Department of Transportation
HIGHWAY DIVISION

Enclosed are revised special provisions for the NE Columbia
Boulevard-NE Weidler Street section of Union Avenue, Unit 3.
The major changes are:

Subject: ORE. 99E-Hwy. No. IE - M.P. 0.00 to m.p. 0.20
ORE. 99E-Hwy. No. IE. - mpp. x 1.00 to m.p. X 0.80

Report of Traffic Conditions

E. BURNSIDE ST.
AT
S.E. & N.E. UNION AVE.

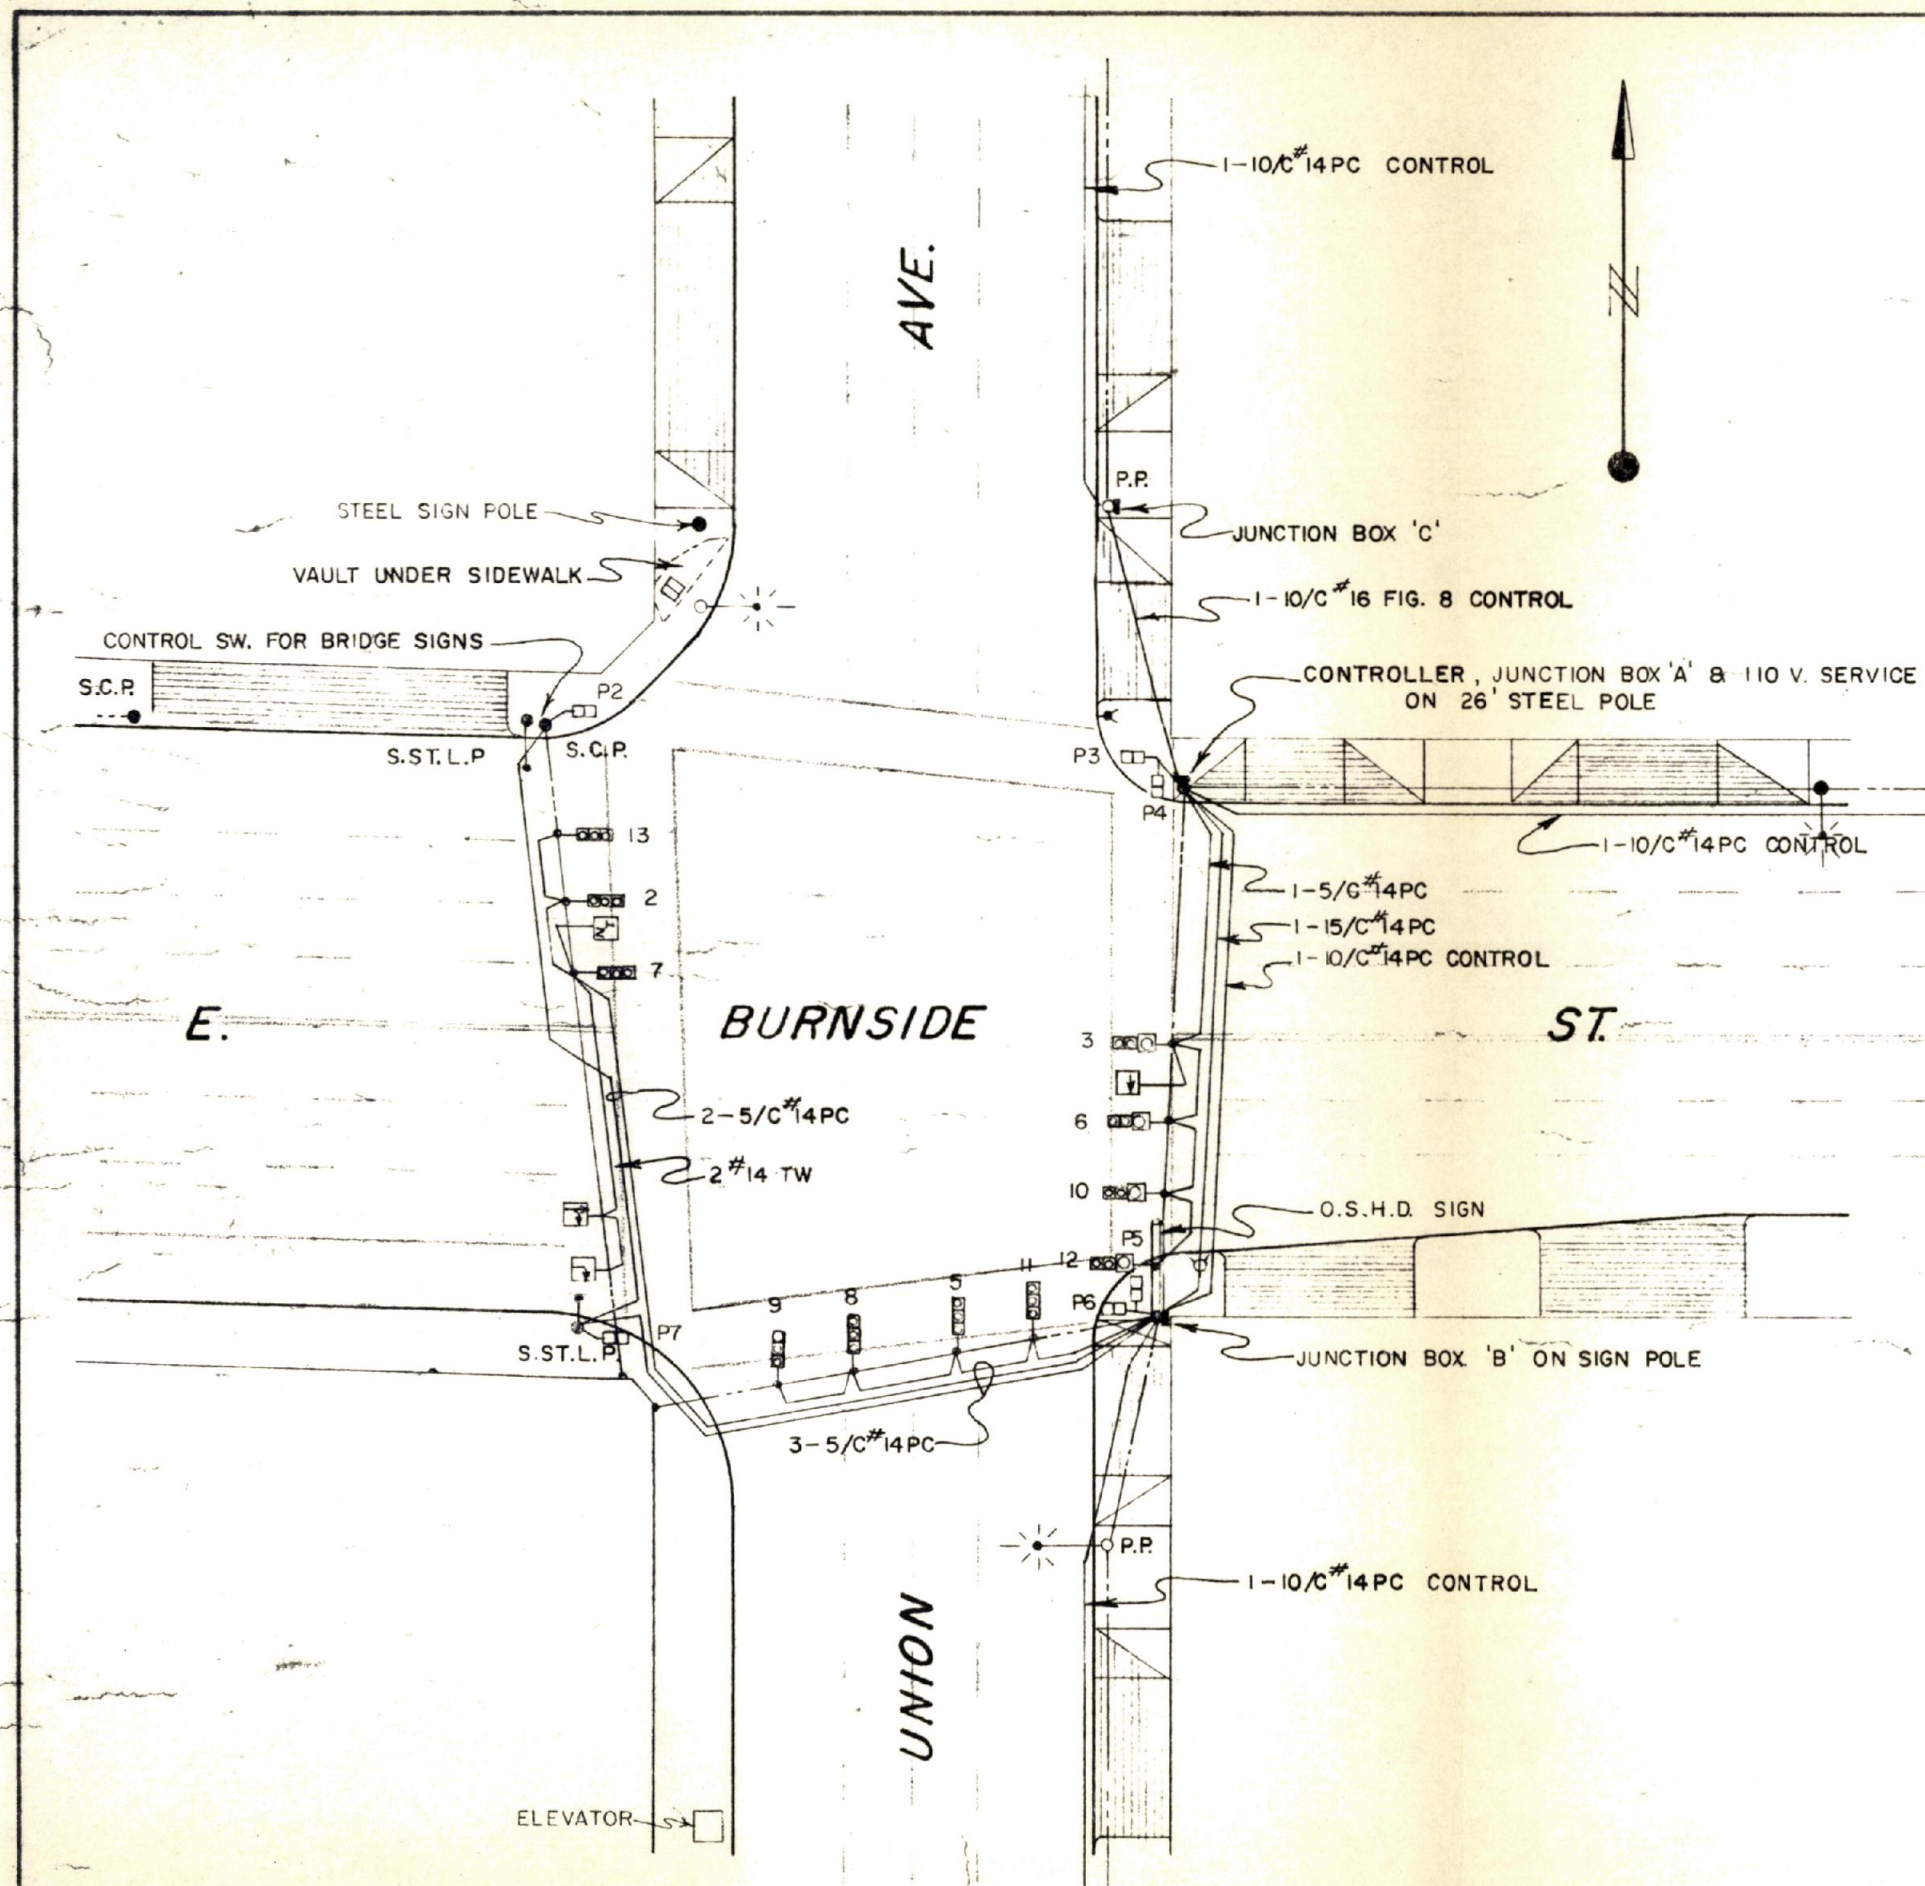
A. E. Burnside at Union Ave.:

1. We approve ~~the~~ installation of backboards on all signal heads (11 total).
2. 4 existing signal heads have 12" reds. The other 7 signal heads are one piece housing construction which requires replacing with complete new signal heads with 12" reds.

As a result of this investigation, it is recommended that backboards be installed on all 10 signal heads at the intersection of Union Avenue and Burnside Street in the City of Portland. It is further recommended that 12-inch red lenses be installed in the seven signal heads which presently have 8-inch red lenses.

Reference to these photographs will show that none of the signal heads at the Burnside Street intersection have backboards. Only three of the ten signal heads have 12-inch red lenses - the remainder are the standard 8" size. Because of the wide streets involved, the number of moving traffic lanes, and the heavy traffic, the existing red signal indications are not considered adequate.
